WORSLEY ALUMINA JOINT VENTURERS BODDINGTON GOLD MINE PROPOSAL

**Report and Recommendations
by the
Environmental Protection Authority**

Bulletin 219 October 1985

FIG. 3
WORSLEY ALUMINA PTY. LTD.
 OTHER MINERALS OPERATION
 100000 1/G BODDINGTON PROSPECT
 PROCESS AND POTABLE WATER
 FLOW DIAGRAM & WATER BALANCE
 J.L. IRISH, 07 SEP 1985
 Civil Engineer/Hydrologist

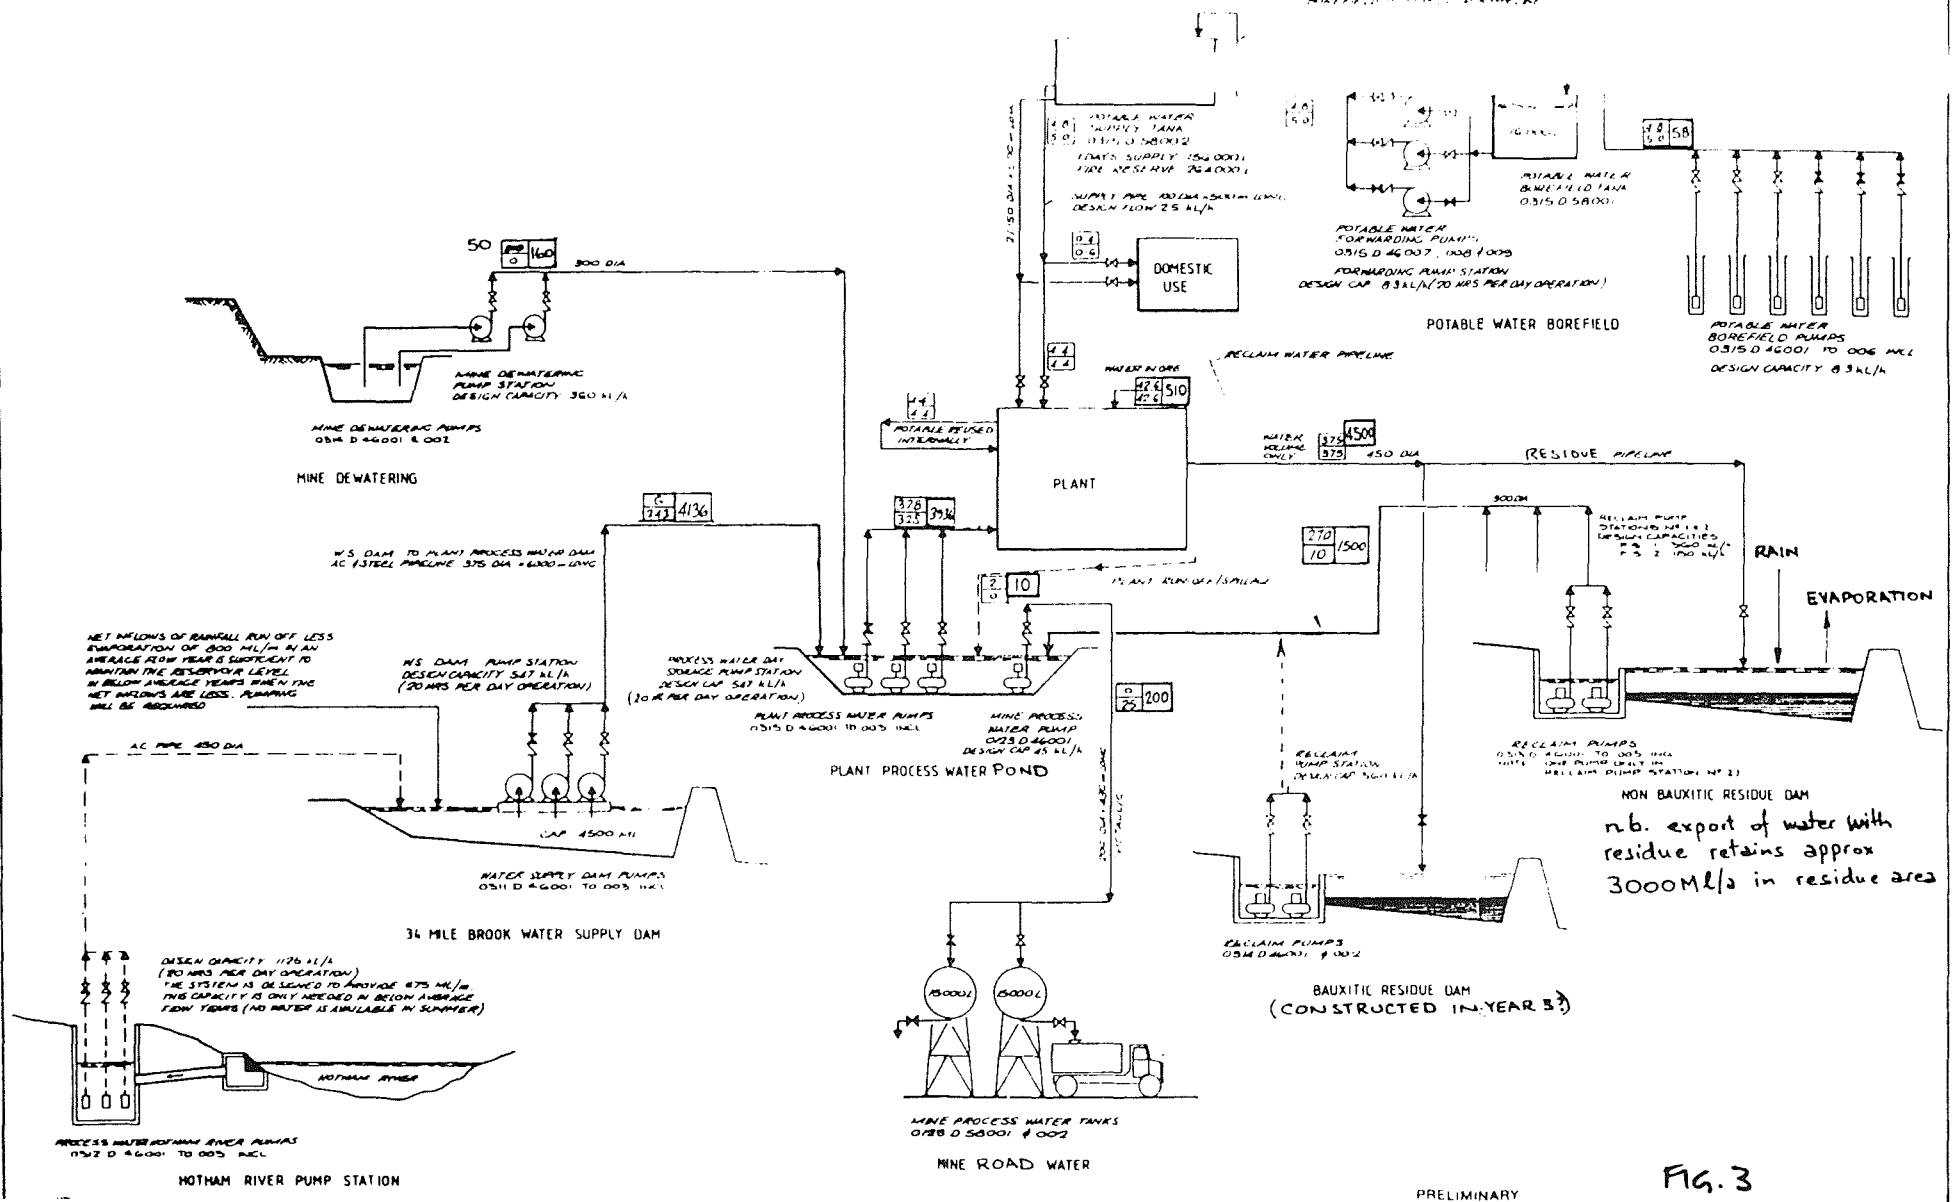
Fig. 3 is a preliminary water balance for an average year, for a plant operating at a capacity of three million tonnes per annum. It shows that water needs to be imported to the plant from the 34-Mile Brook Water Supply Dam even in winter months, so that excessive rainfall on the residue storage areas can be accommodated by:

- (i) increasing the pumping rate from the residue area back to the plant, substituting for water from the 34-Mile Brook Dam; and
- (ii) temporary ponding in the residue area.

The net runoff volume from the residue area (1500ML/a) is based on various computer models by Kinhill Stearns and GHD-Dwyer (WA) Pty Ltd, Consulting Engineers, and allows for runoff from separate storage areas for bauxite and non-bauxitic residue.

BODDINGTON GOLD MINE
 Fig. 3. Project General Arrangement, including Contour, Camp Location.

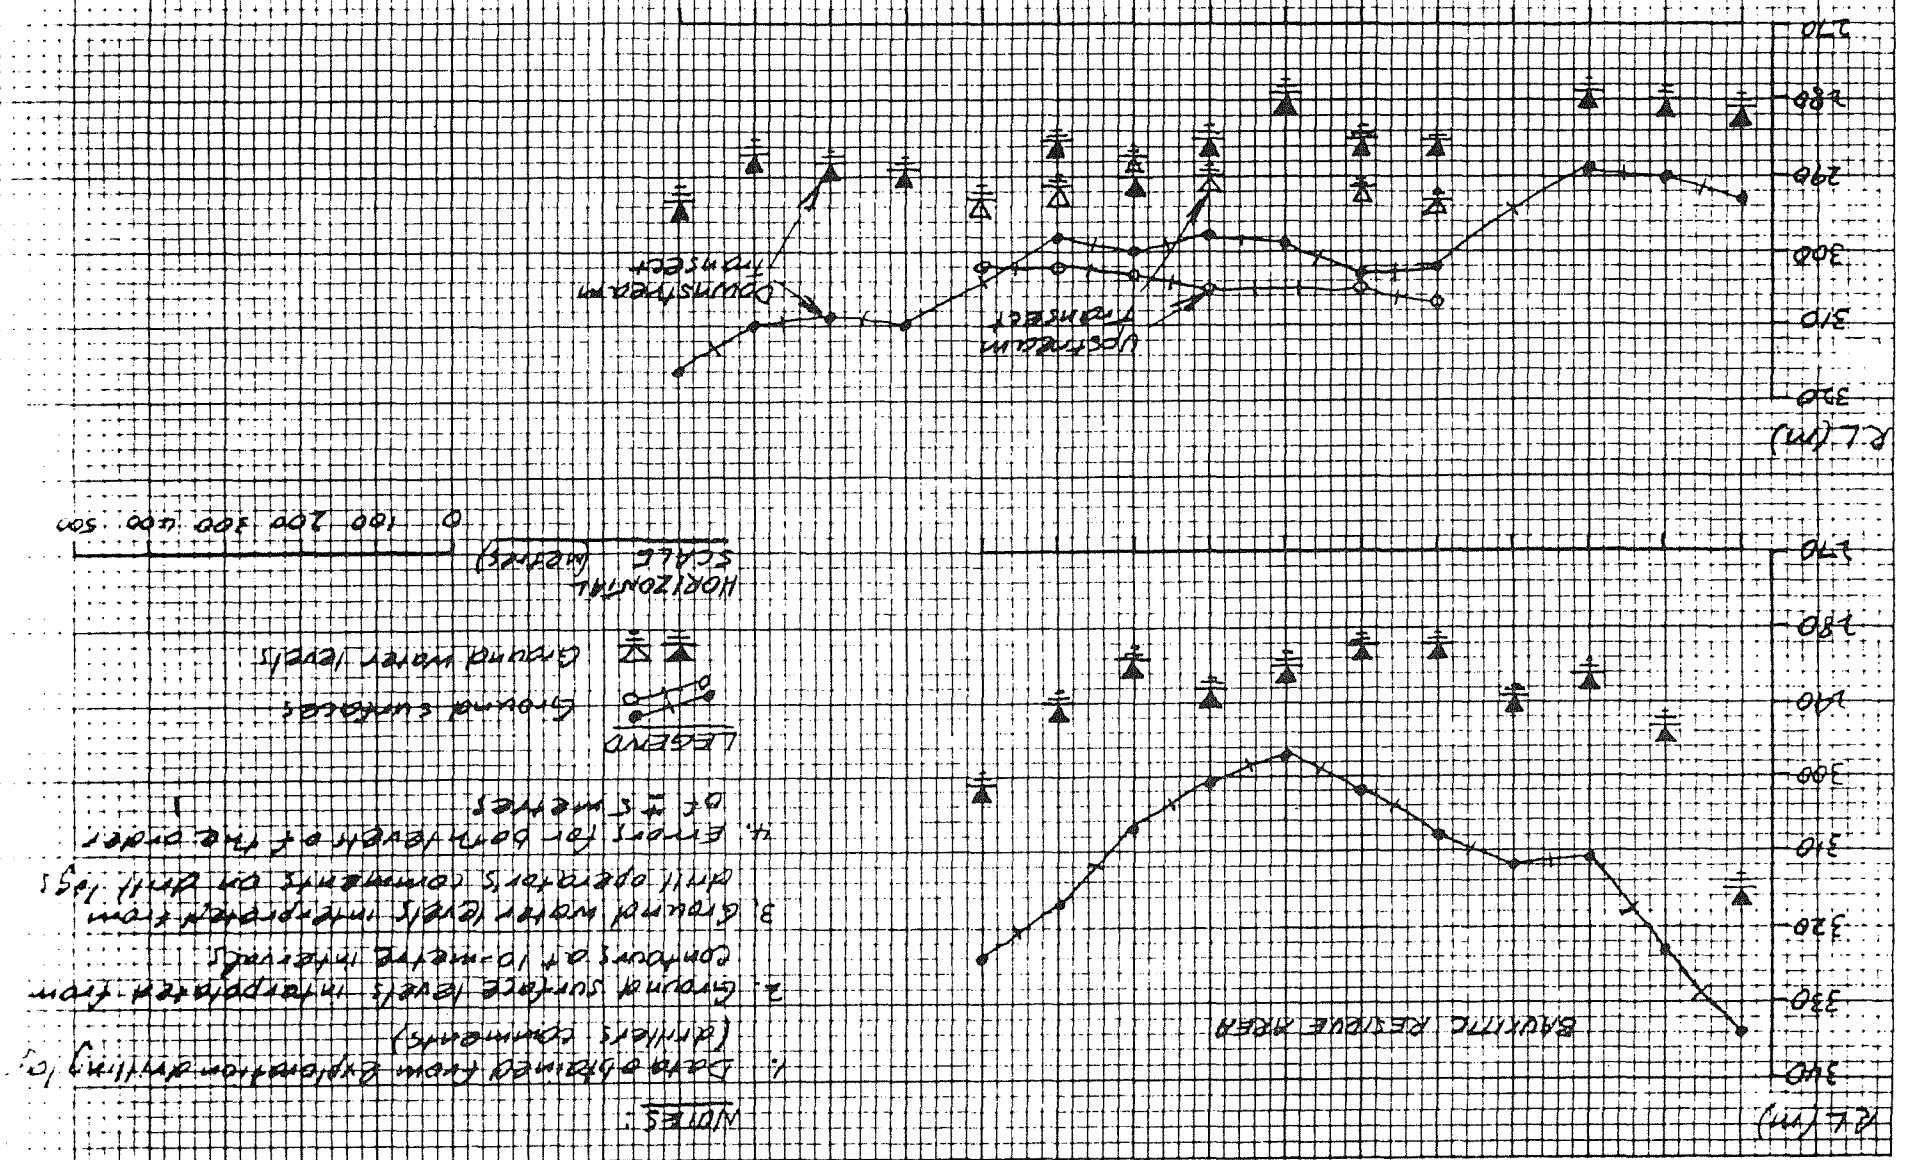
The construction camp for the Boddington Gold Mine is, on current planning, to be located on private property (Bunning Bros), as shown in Fig. 3. The camp, which will be equipped with its own sewage treatment plant, will be established, operated and de-commissioned in accordance with the appropriate State and local government statutes and regulations.

BODMINION GOLD MINE
 FIG. 2. GROUNDWATER LEVELS AS ASSESSED FROM
 EXPANSION DRILLING

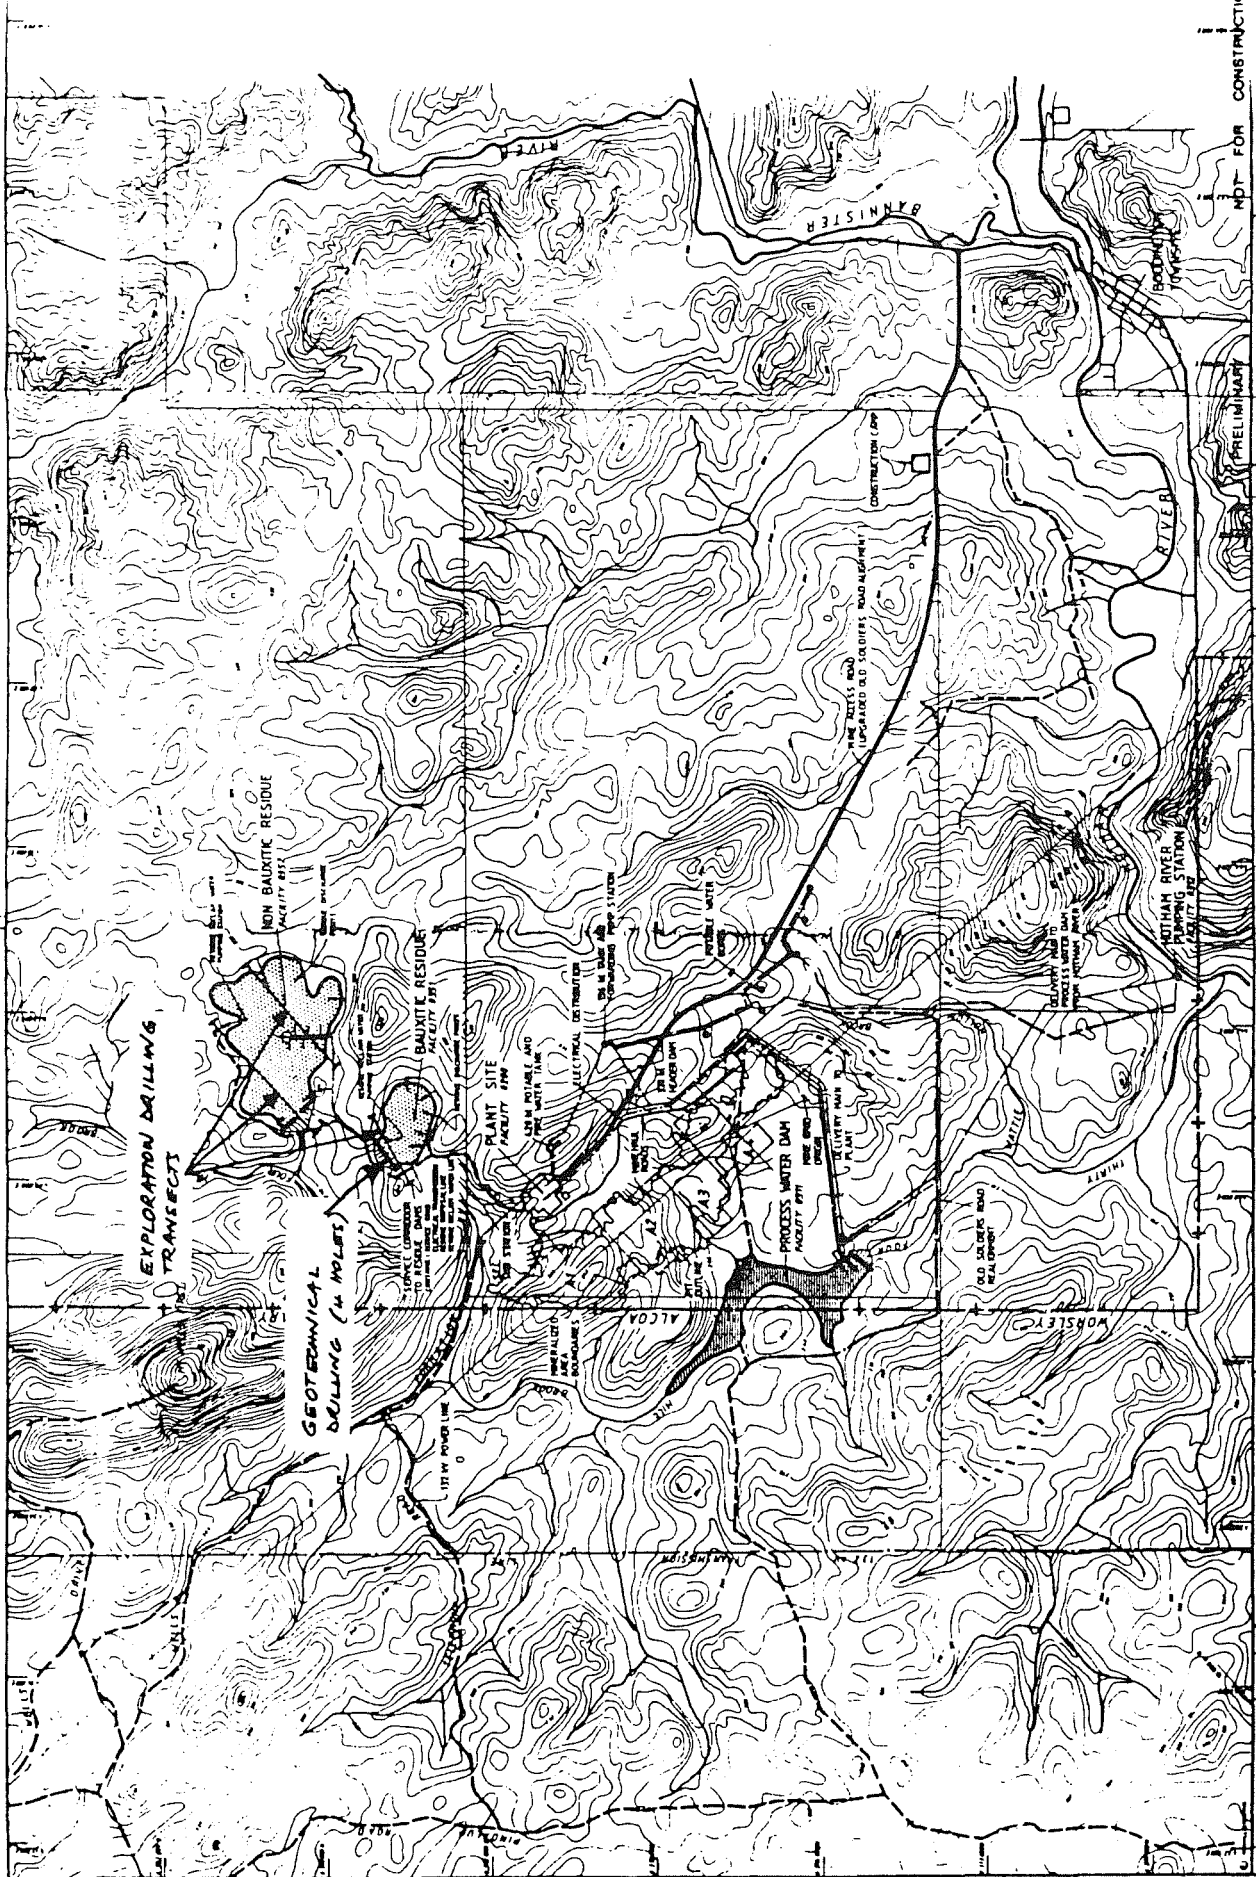
For the non-bauxitic area, Fig. 2 also indicates that groundwaters in this area have an hydraulic gradient of some 2-5 metres per kilometre. This figure is derived by comparing groundwater levels on the upstream and downstream transects. Given the relatively imprecise nature of the data, this figure can only be regarded as indicative, but in at least a qualitative manner it does suggest a predictable groundwater regime, similar to those of other areas of the Darling Range.
